This document is generated in response to the queries asked in the e-mail from Compliance Certification Services titled "Kyocera Wireless Corp, FCC ID: OVFKWC-KX16, Assessment NO.: AN05T5286, Notice#1". The queries asked in the e-mail received by Lin Lu on 14th of November 2005 are listed below followed by the response the questions.

Subject: Kyocera Wireless Corp, FCC ID: OVFKWC-KX16, Assessment NO.: AN05T5286, Notice#1

Exhibit 8: OVFKWC-KX16

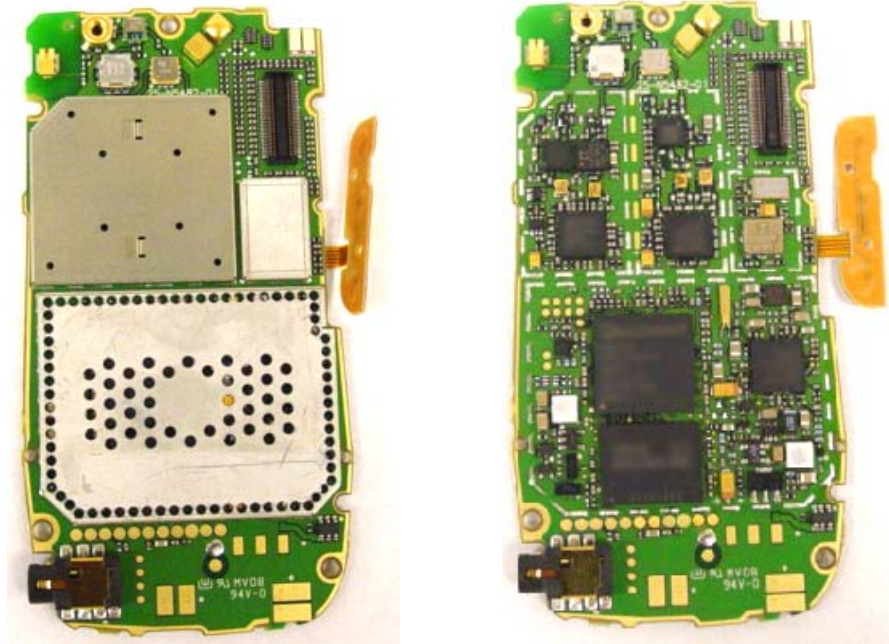
Question #2: Please provide internal photos with Unitech as PCB manufacturer.

The internal photos are submitted along with this response. The component placement and board layout are kept the same as before.
